Project  
65 Kingsway - Base Scheme

Title  
Proposed Roof Plan

Drawing No.  
1914-BG-01-08-DR-A-20.210

Indicates proposed changes to approved planning application 2019/6088/P and approved LBC 2019/6270/L

01 Proposed Roof Plan  
20.211 1:100@A1, 1:200@A3

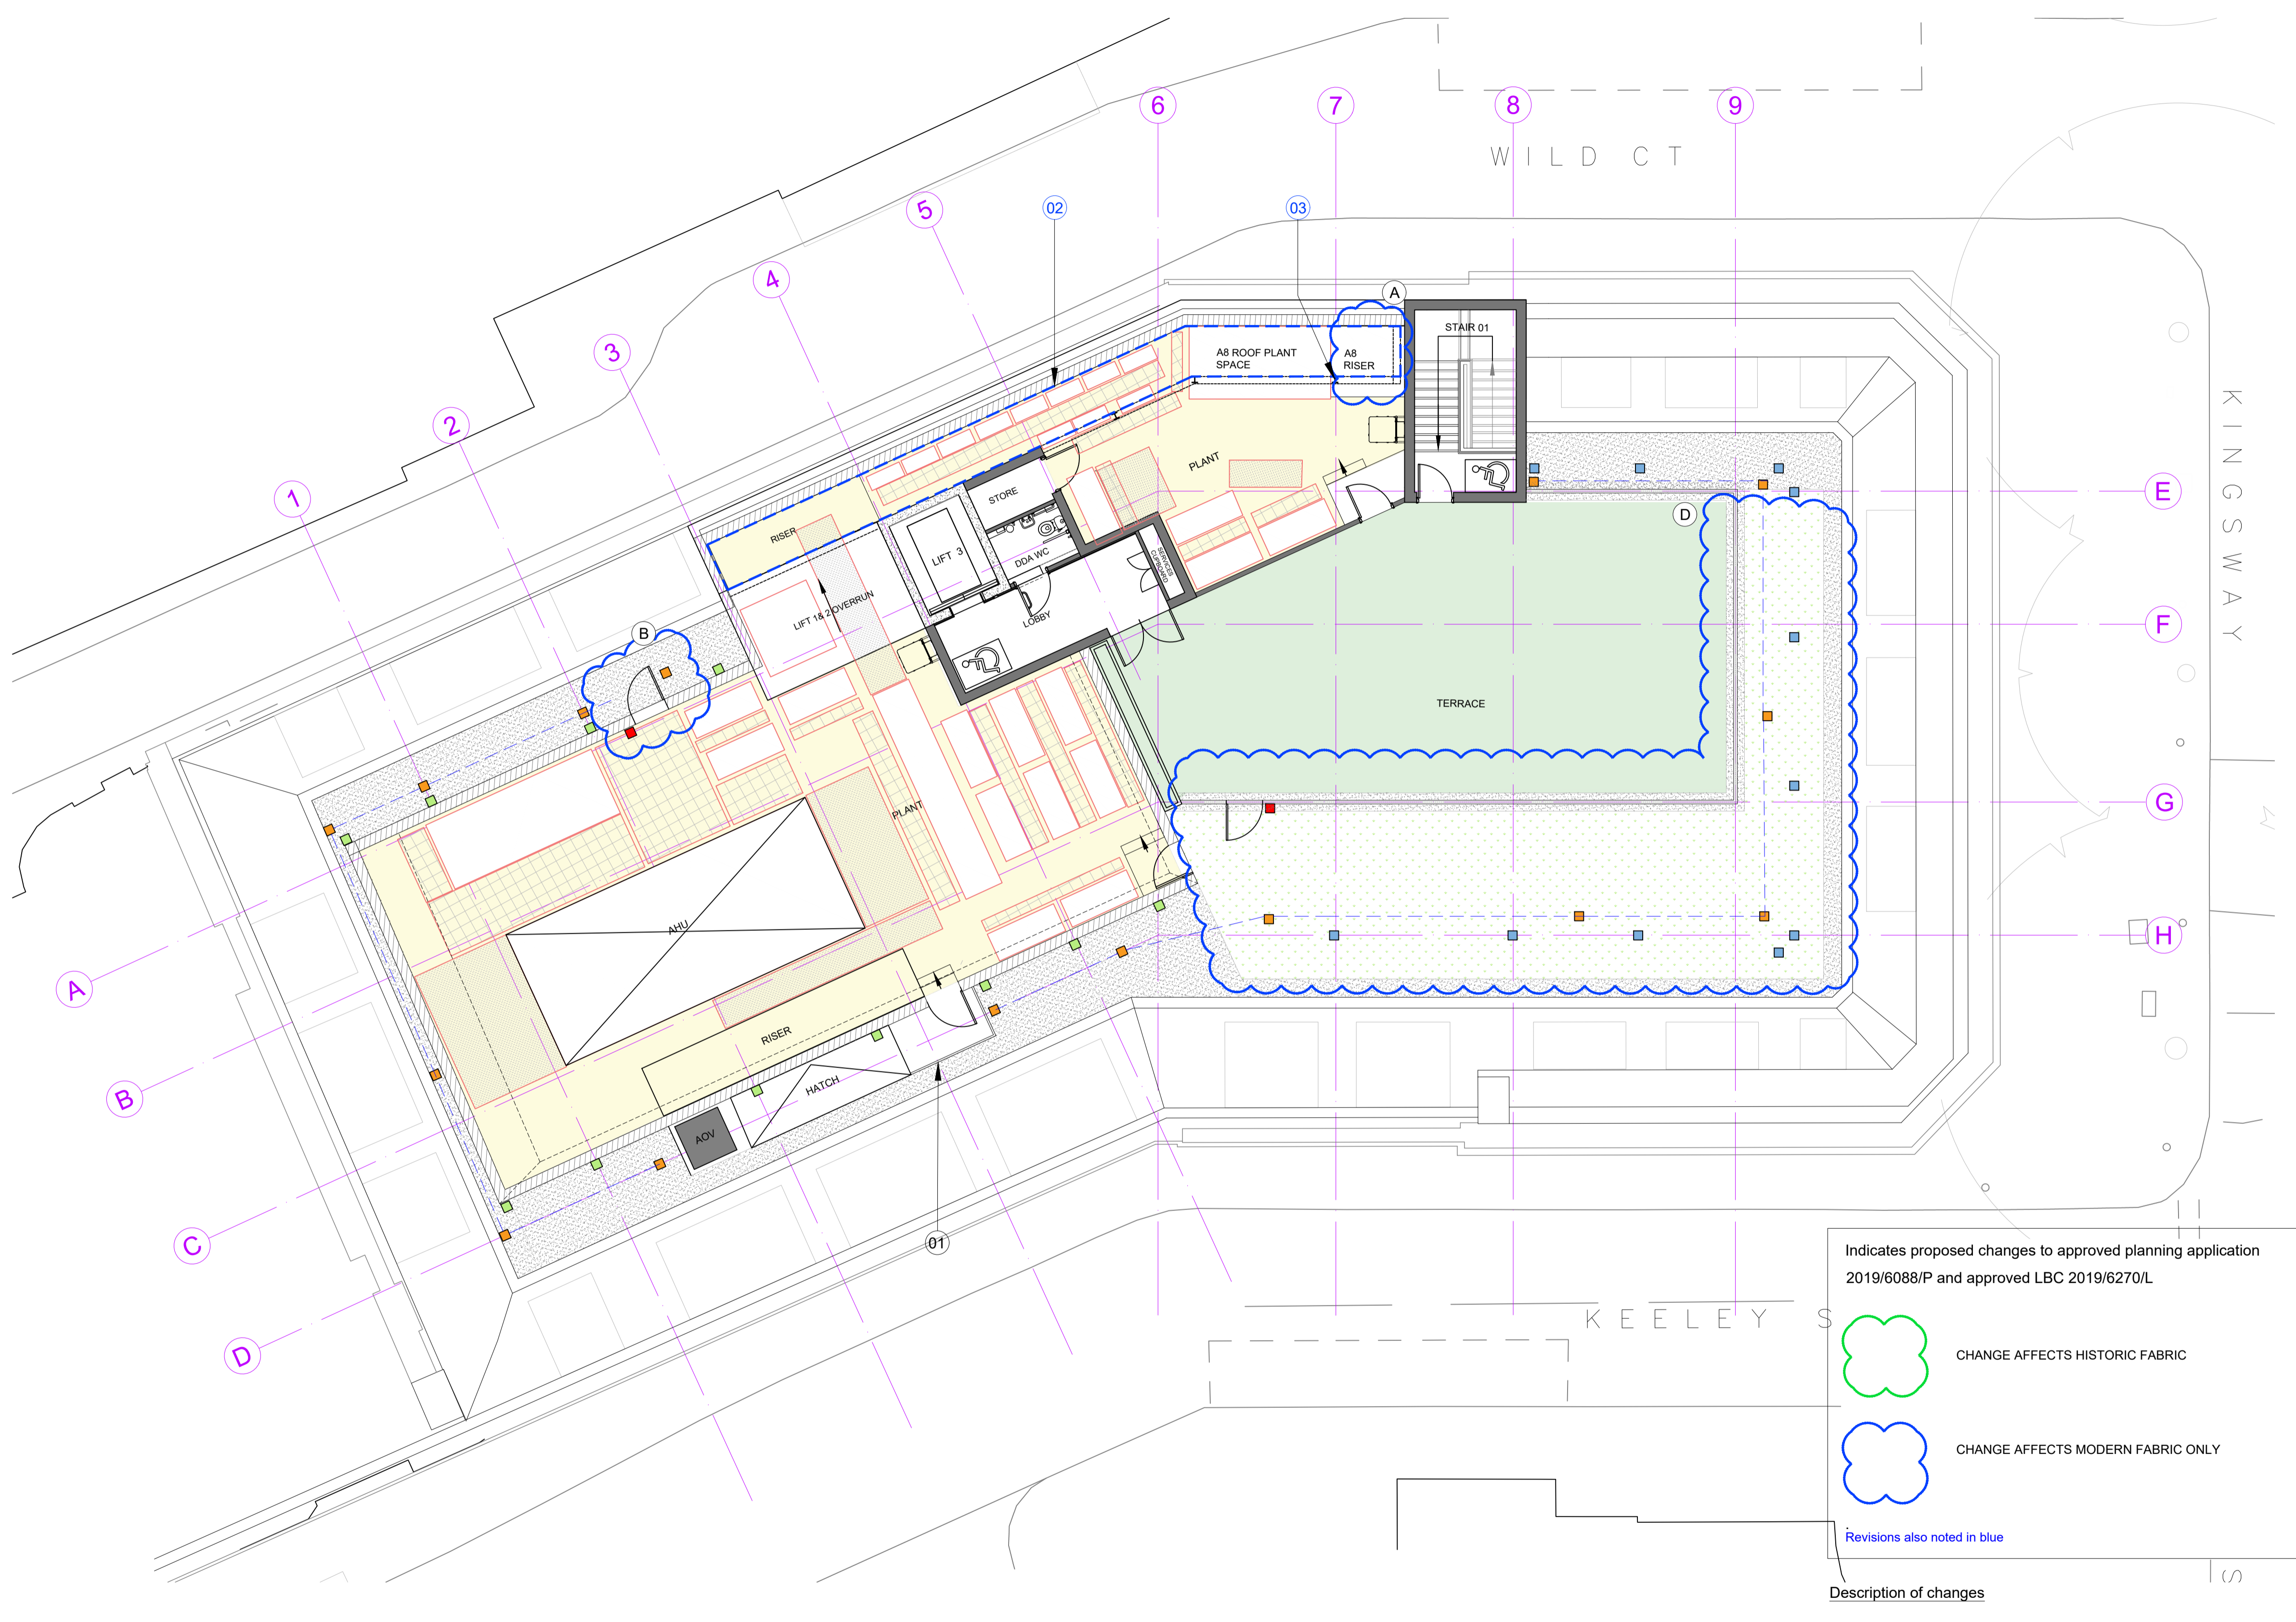
1. Metal guarding around access hatch entry. To be same colour as plant screen
2. High level walkway for maintenance access to abseil system, shown dotted in blue. Height of walkway to match height of plant screen
3. New supporting columns for high level walkway.

- A. F/F Lift omitted. Riser from second floor to roof in place.
- B. Additional door to plant enclosure for maintenance access
- C. Fall arrest and abseil anchors included
- D. Terrace extent is reduced. Set back increases along Kingsway and Keeley Street
